Service Bulletin

DATE December 1, 1976

NUMBER 2902-30001

FIGURE 1. TYPICAL SECTION AND FRAME CONDITIONS.

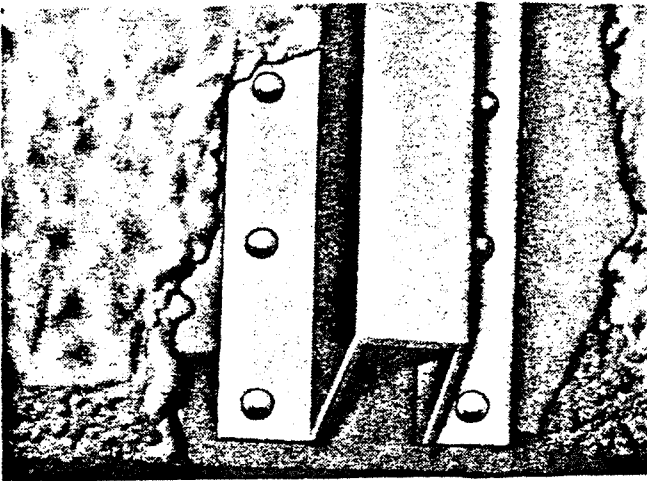
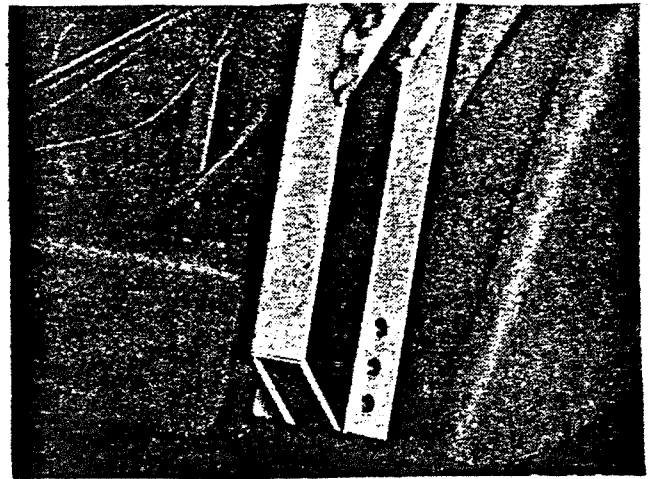
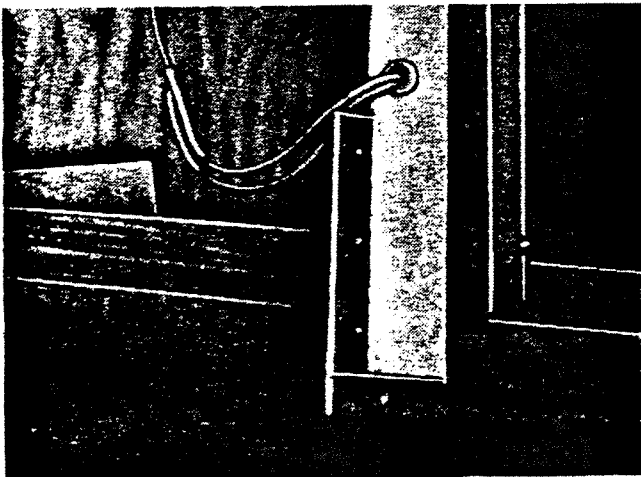
<p>ATTENTION: SERVICE MANAGER</p>	<p>GROUP 2</p>
<p>3. Inspect all body section to frame mounts and door for missing rivets, possible movement or disfiguration of rivets (Figure 2) or movement of body section or door frame away from lower frame (Figures 1 and 3).</p> <p>4. Inspect shear panels for missing rivets, possible movement or disfiguration of rivets (Figure 2) or movement of shear panel away from upper body sections. Note: If rivets show signs of movement, add two new rivets between each pair of existing rivets as shown in Figure 2.</p> <p>5. If all upper body section to lower frame rivets are in place and show no signs of deterioration, no reinforcement is necessary <u>except</u> at the right and left body sections (L4 and R4, Figure 3) forward of the rear wheels. New frame reinforcing angles will be added at these points regardless of the condition of the existing section and rivets.</p>	<p>SUBJECT Frame Reinforcement Instructions</p>

FIGURE 3. UPPER STRUCTURE TO FRAME REINFORCEMENT.

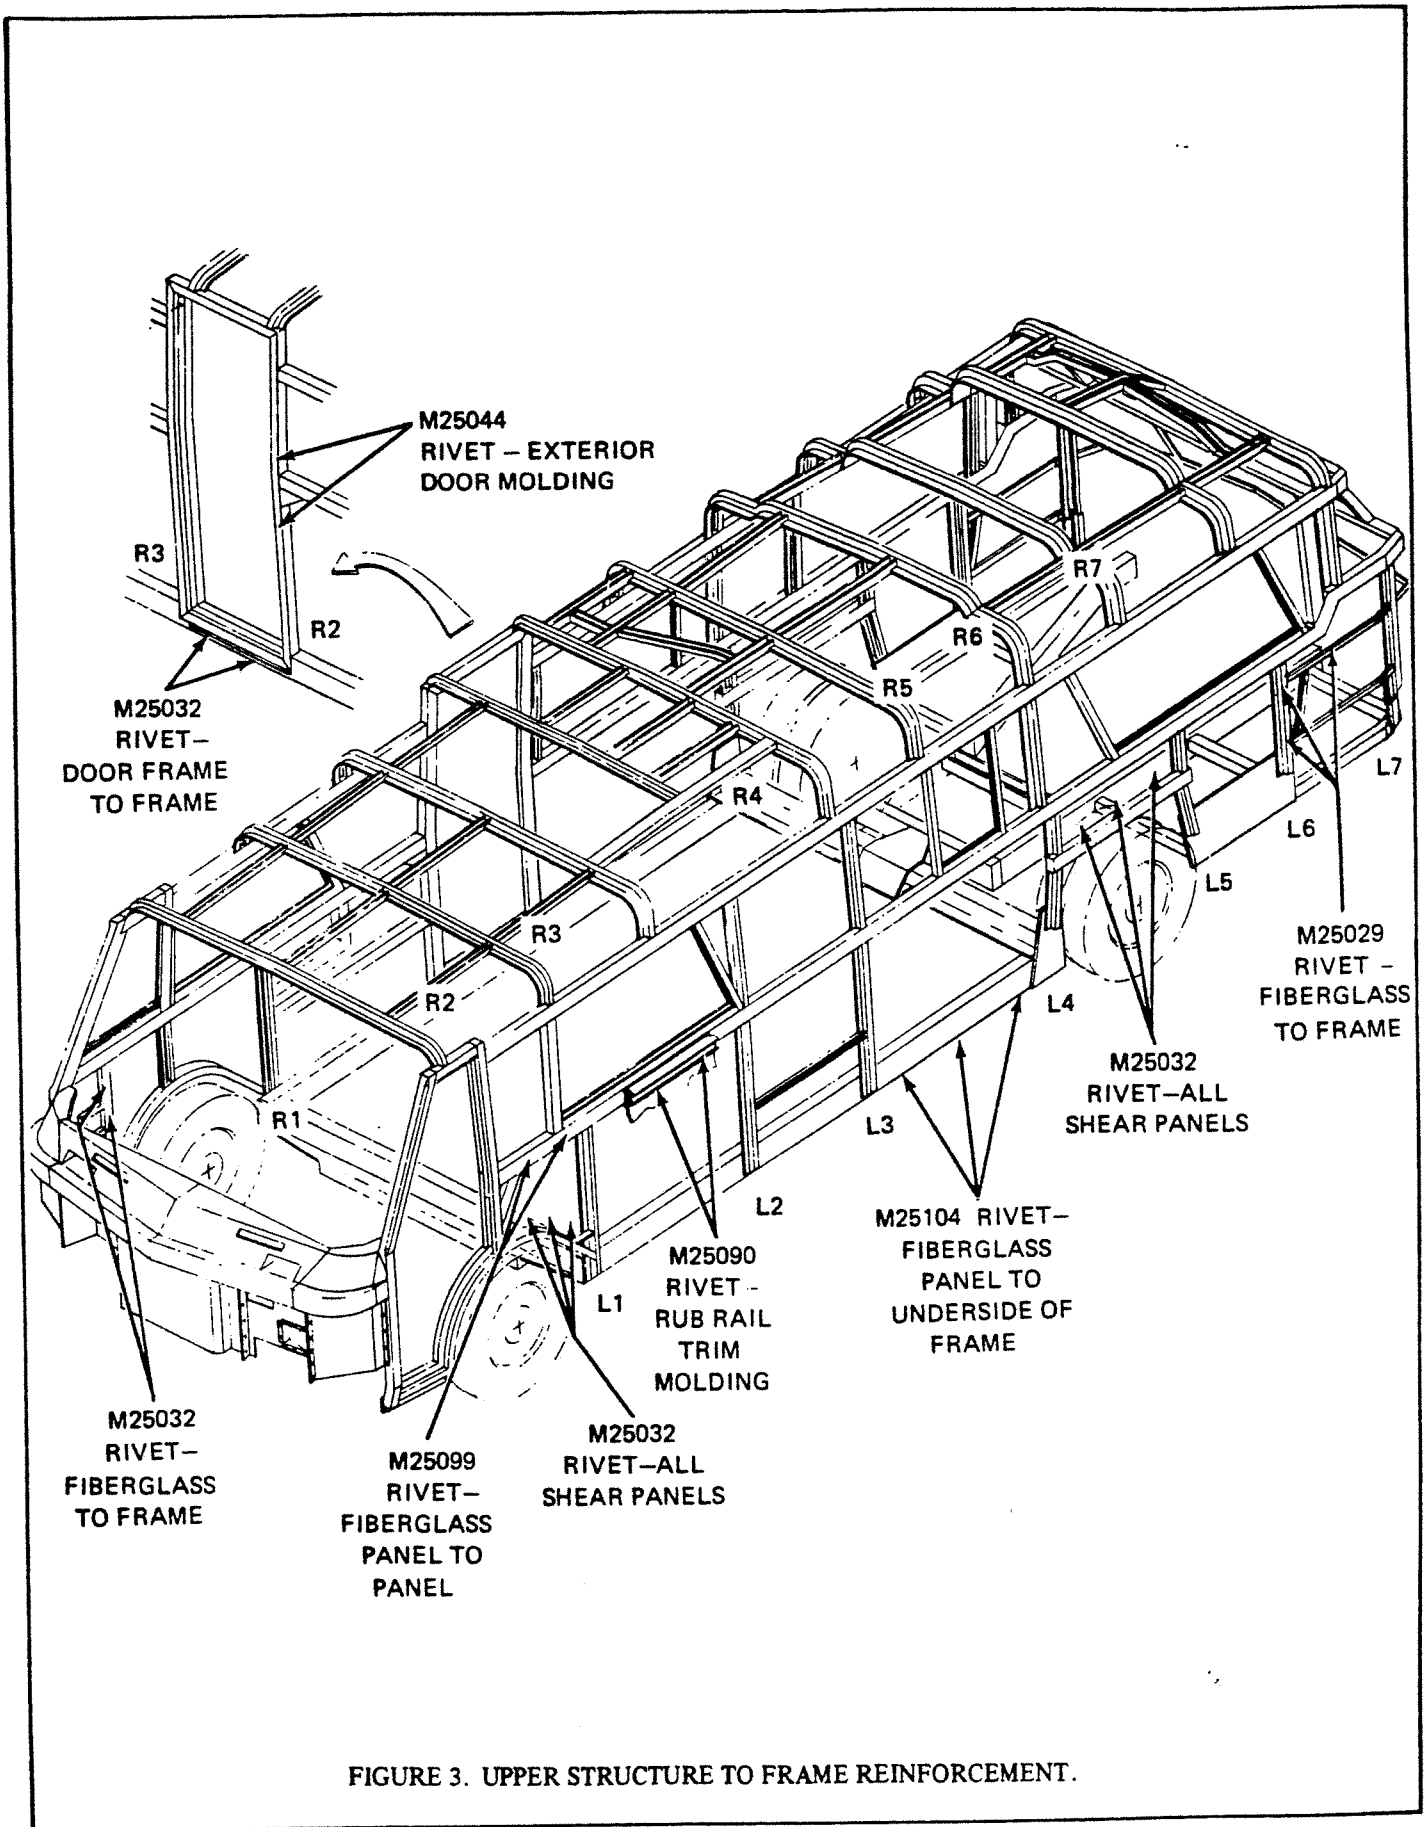
<p>ATTENTION: SERVICE MANAGER</p>	<p>GROUP 2</p>
<p>Condition 1 - Right and left sections forward of rear wheels (positions L4 and R4 in Figure 3) need reinforcement ---4 man hours. Please note that it is not necessary to completely remove coach panels to reinforce for this condition (see Joint Reinforcement Figure 5).</p> <p>Condition 2 - Right and left sections forward of rear wheels (L4 and R4) and all right side sections between rear wheel and front wheel (R3, R2 and R1) plus shear panels in front and rear right side wheel wells (see Figure 3) need reinforcement---8 man hours.</p> <p>Condition 3 - Right and left sections forward of rear wheels (L4 and R4), all right side sections between rear wheel and front wheel (R3, R2 and R1) plus shear panels in front and rear right side wheel wells and left side sections rear of front wheel (L1, L2 and L3), plus shear panels in front and rear left side wheel wells (see Figure 3) need reinforcement. Call factory service representative 408-289-3665 regarding warranty reimbursement <u>before</u> proceeding with the work.</p> <p>Condition 4 - Right and left sections forward of rear wheels (L4 and R4), all right side sections between rear wheel and front wheel (R3, R2 and R1) plus shear panels in front and rear right side wheel wells and left side sections rear of front wheel (L1, L2 and L3), plus shear panels in front and rear left side wheel wells, and all four corners of passenger door frame (see Figure 3) need reinforcement. Call factory service representative 408-289-3665 regarding warranty reimbursement <u>before</u> proceeding with the work.</p> <p><u>INSPECTION</u></p> <p>A thorough inspection of each coach is essential before proceeding with the work to determine if all parts and equipment are in stock and to determine extent of frame reinforcement required.</p> <ol style="list-style-type: none"> 1. Release lower edge of fiberglass side panels on left and right sides of coach (see Figure 5). 2. Cut away foam insulation just enough to inspect all rivets on body sections and shear panels (Figure 1A). 	<p>SUBJECT Frame Reinforcement Instructions</p> <p>MODEL (S) AFFECTED All Motor Homes 00001 to 01050 Model 2900R</p>

<p><u>ACCOMPLISHMENT INSTRUCTIONS</u></p> <p>A. <u>Hull Section to Frame Angles</u> (Figure 3, positions L4, R4, R2 and R3)</p> <ol style="list-style-type: none"> 1. Make certain coach is level at all four jacking points. Jack up body until distance from horizontal strut (just forward of right rear wheel) to bottom of frame is 39 1/4" as shown in Figure 4. 2. Realign rivet holes as close as possible. 3. Close gap between upper body section and lower frame with C clamp. 4. Cut out shear panel only as necessary to install reinforcing angles. 5. Grind or file off existing rivet heads to make angles flush with shear panel. 6. Apply zinc chromate primer to reinforcing angles in all areas that come in contact with aluminum. 7. Place reinforcing angles (5109097-01) against the body section and flush with lower frame. Secure with C clamps. 	<p>MODEL (S) AFFECTED</p> <p>All Motor Homes 00001 to 01050 Model 2900R</p>

FIGURE 5. REINFORCING ANGLES.

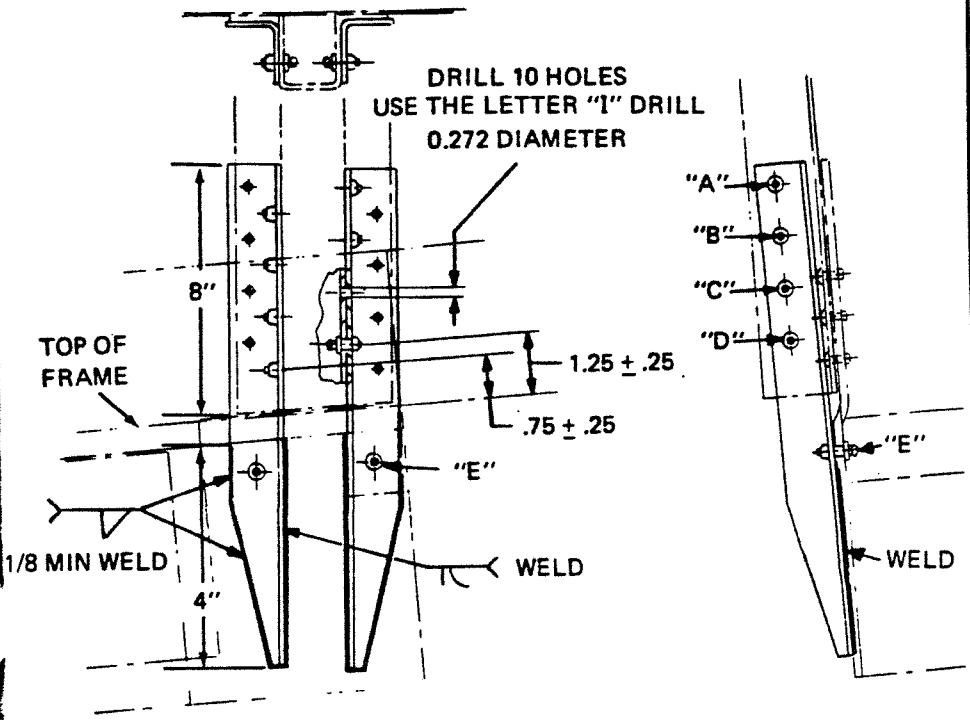
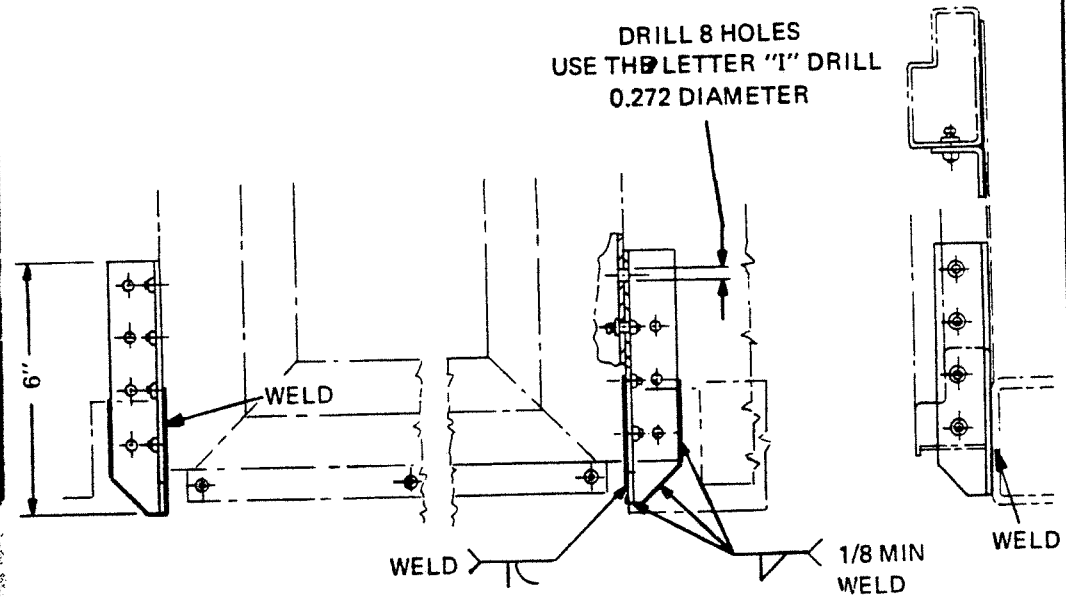
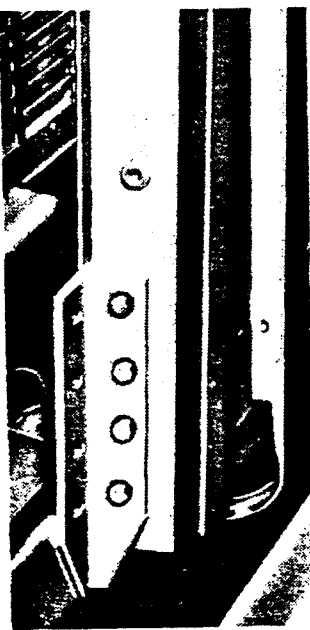
<p>ATTENTION: SERVICE MANAGER</p>	<p>GROUP 2</p>						
<p>8. Drill two holes through each angle, one into body section and one onto the lower frame at points "D" and "E" in Figure 5. Use an "I" size drill.</p> <p>9. Install one fastener (5109247-04, colored red) through body section and lower hole of angle ("D" in Figure 5) to secure each angle. Use special "Huck" gun on fastener.</p> <p>10. Install one fastener (5109247-05, colored yellow) through frame and lower hole of angle ("E" in Figure 5) to secure angle at position L4 only (see Figure 3).</p> <p>11. Install one fastener (5109247-05, colored yellow) through frame and lower hole of angle ("E" in figure 5) to secure angle at position R4 only (see Figure 3). Use special "Huck" gun on fastener.</p> <p>12. Drill three holes through each angle into body sections for positions "A", "B" and "C" in Figure 5. Use an "I" size drill.</p> <p>13. Install fasteners (5109247-04, colored red) through body section to secure each angle. Use special "Huck" gun on fastener.</p> <p>14. Remove paint and scale in areas to be welded. Degrease using small disc sander or wire brush prior to welding.</p> <p>15. Weld angle to lower frame as indicated in Figure 5. A metal to metal fit is desirable. If gap exists, make two welding passes.</p> <p>B. <u>Hull Section to Frame</u> (Figure 3, positions L1, L2, L3, L5, L6, L7 and R1, R5, R6 and R7)</p> <p>1. Drill out old rivets and replace with "Huck" fasteners per table listed below:</p>

JOINT REINFORCEMENT – POSITION L4-R4 ONLY (FIGURE 3)

PASSENGER DOOR REINFORCEMENT – POSITION R2 AND R3 ONLY (FIGURE 3)
